Water
May 2019

**ALBERTA TRANSPORTATION SPRINGBANK OFF-STREAM RESERVOIR PROJECT
 RESPONSE TO NRCB AND AEP SUPPLEMENTAL INFORMATION REQUEST 1, JULY 28, 2018**

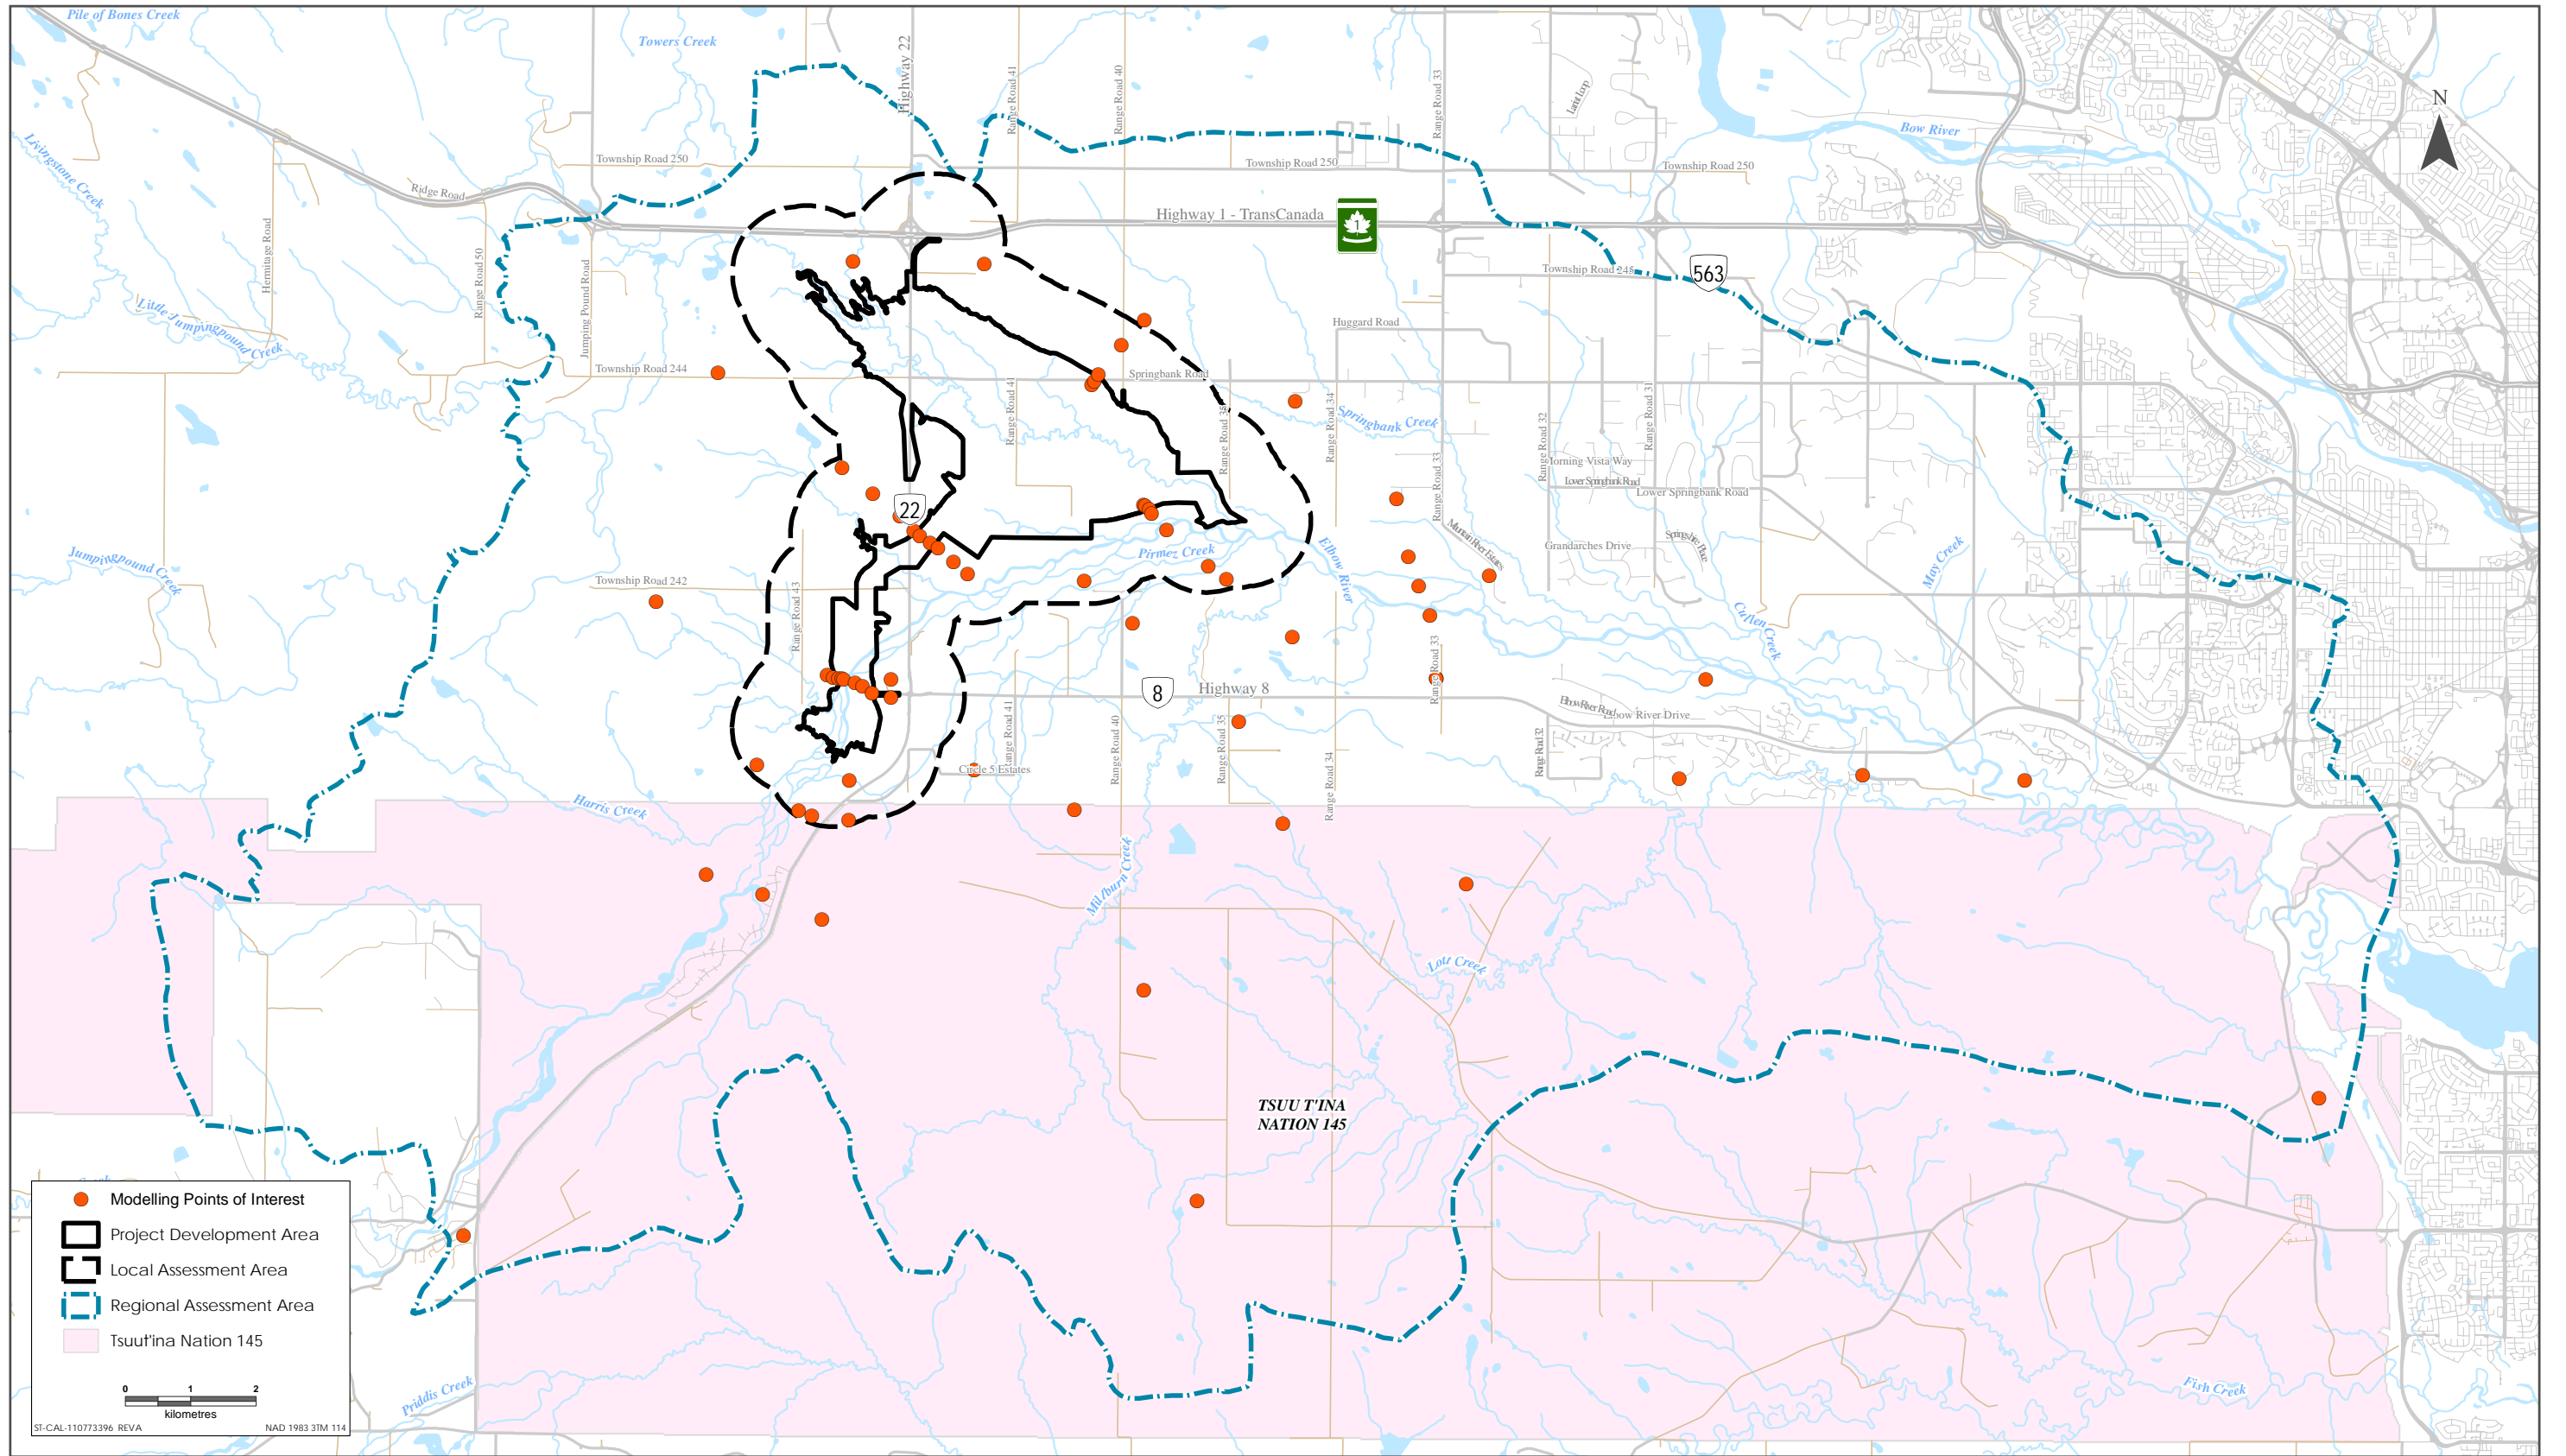
Last paragraph: potential locations of interest were identified, *up to near the LAA boundary*. Two points were within the RAA (shown on Figure 5-5).

- a. Points of interest have been updated in the Hydrogeology TDR Update, Section 5.4 (see the response to IR42, Appendix IR42-1). A total of 67 points were chosen across the groundwater LAA and expanded RAA to evaluate potential effects on groundwater levels from the construction and operation of the Project. The points are presented in Figure IR224-1 and were chosen as follows:

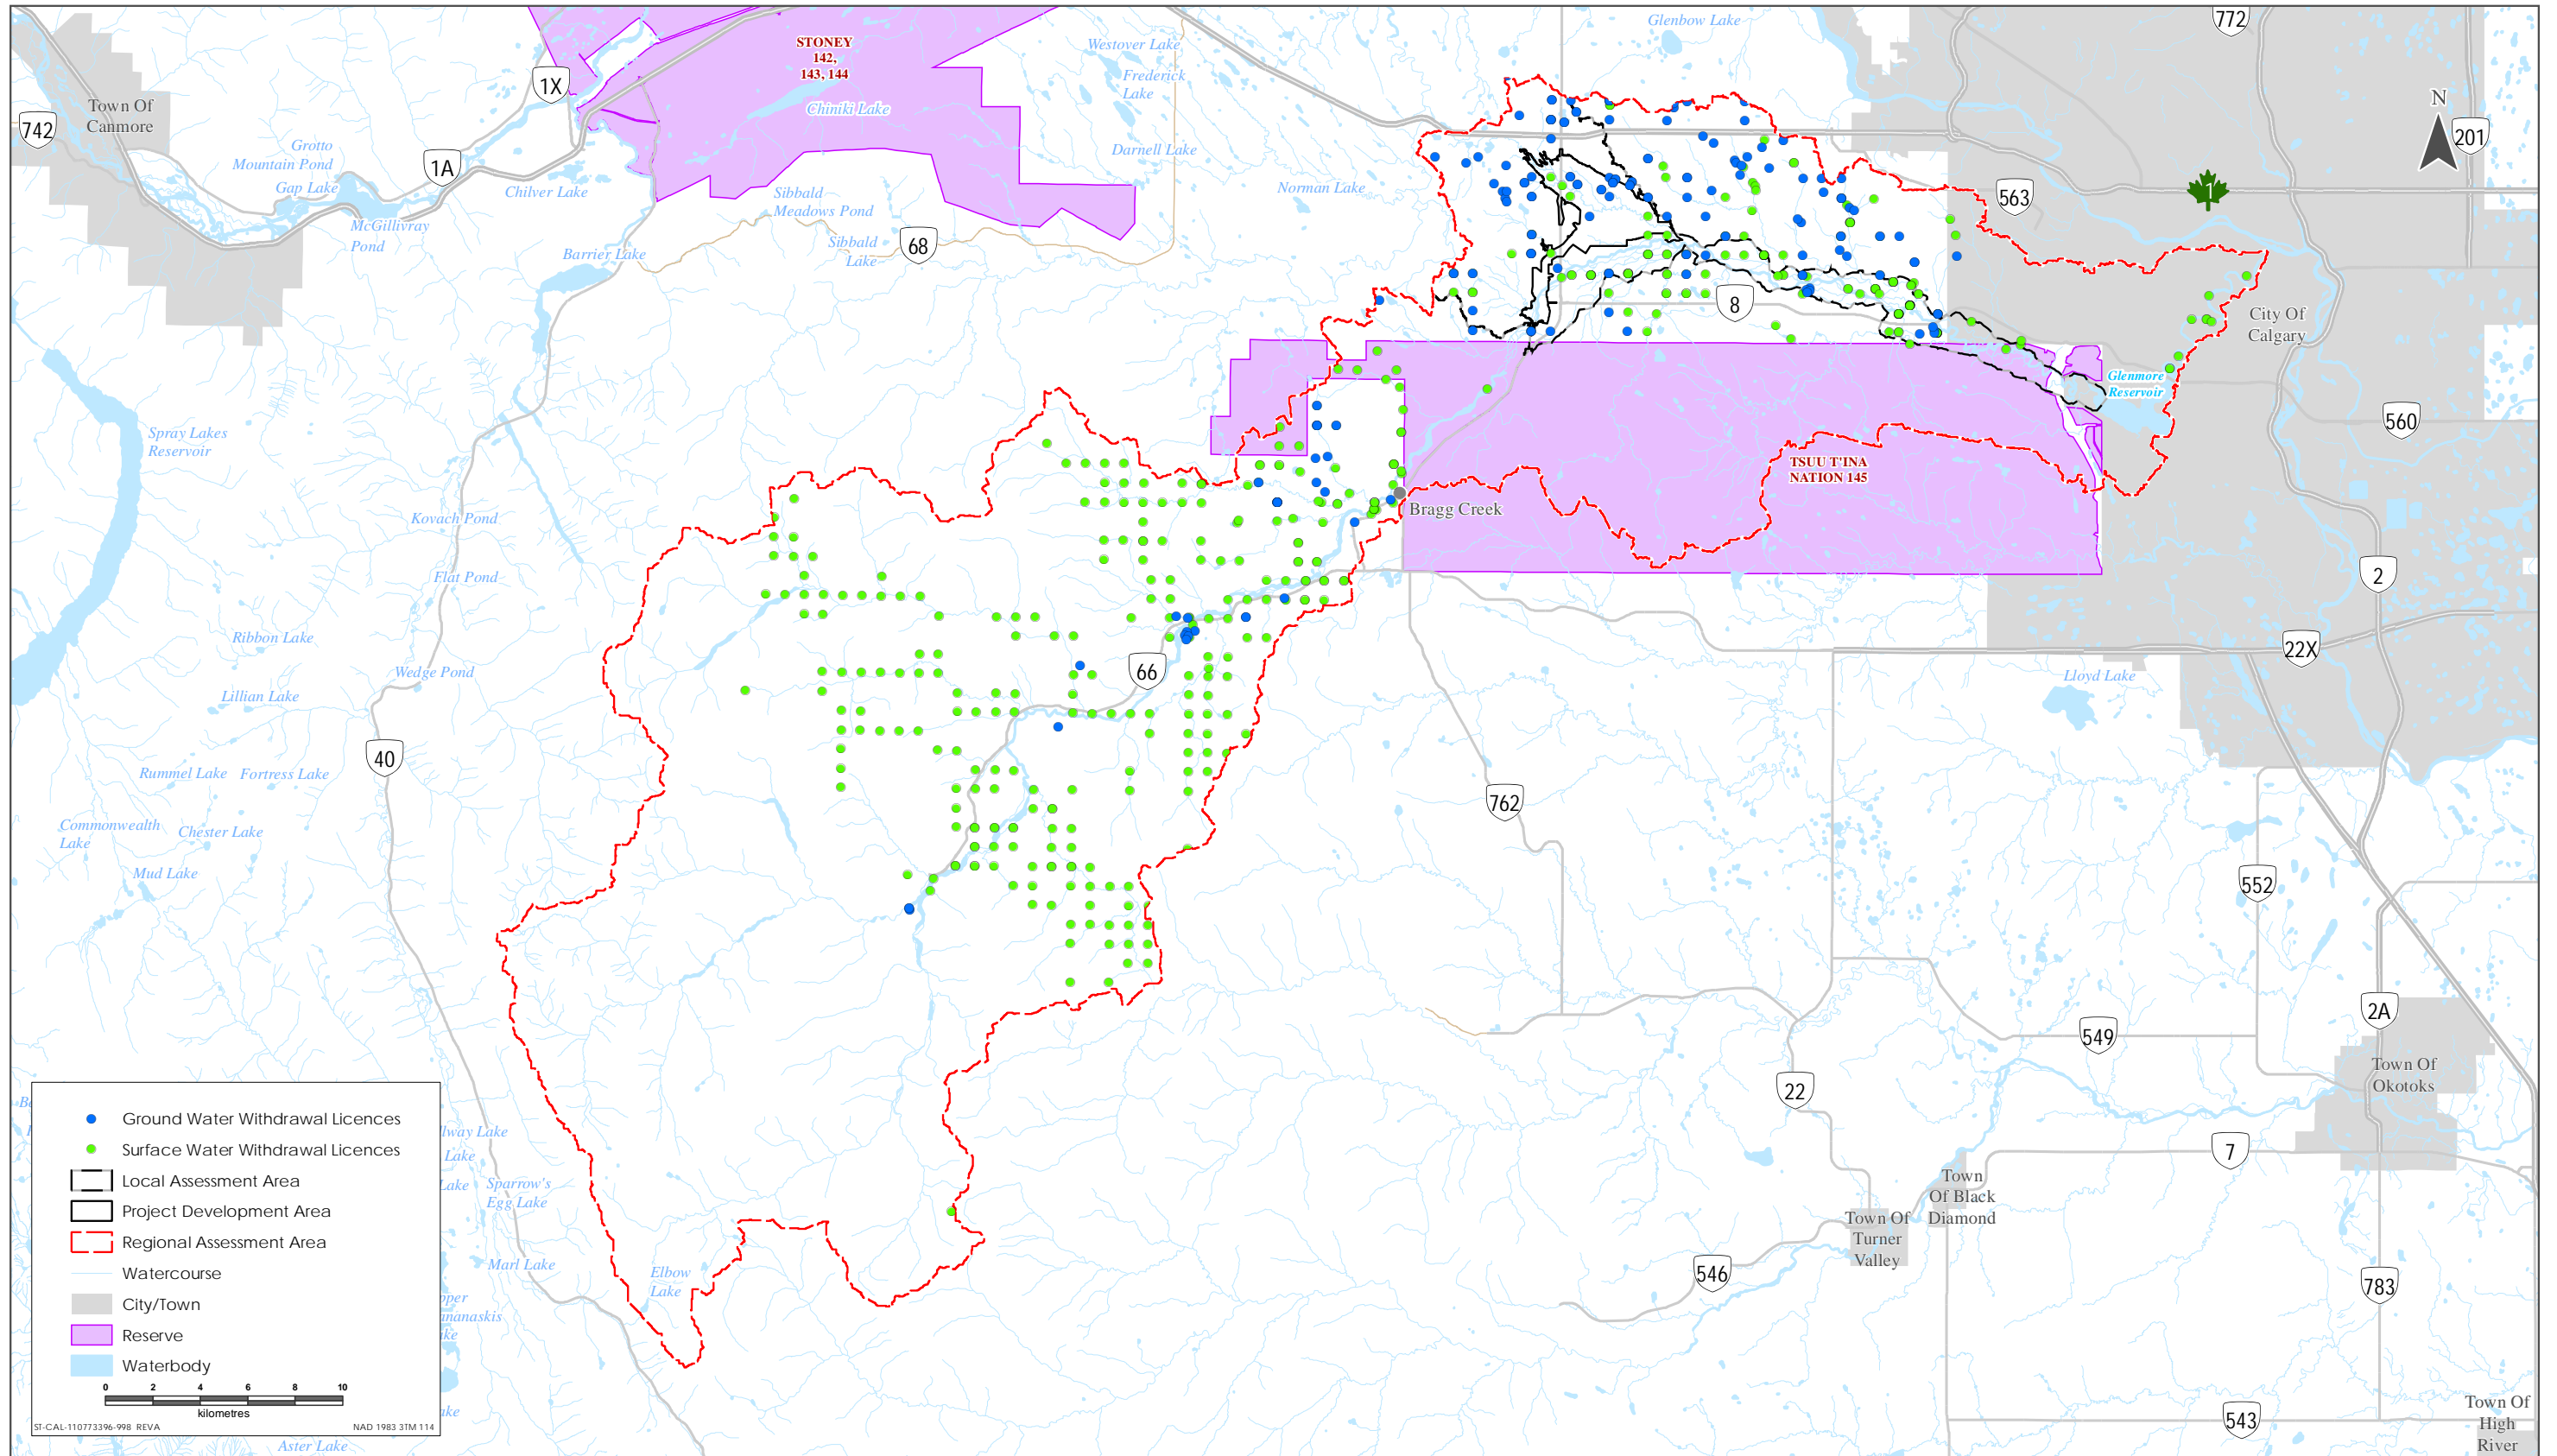
- a. Include map showing locations of the water licences in the LAA and RAA (LAA and RAA boundaries as per Figure 6-1 in Volume 3A_S06).
- b. Provide more detail on each of the licences including the types of licences, source of water, location etc.
- c. Describe whether these water licences will be affected due to the project and identify the affected licences.
- d. What will be the mitigation measures be for the affected licences?

- a-b. The location of water withdrawal licences and allocations within the hydrology RAA is provided in Figure IR274-1. The hydrology RAA is the Elbow River watershed. Appendix IR274-1 contains two tables, Table IR274-1 and Table IR274-2 that list all surface water and groundwater licences and allocations within the Elbow River watershed.
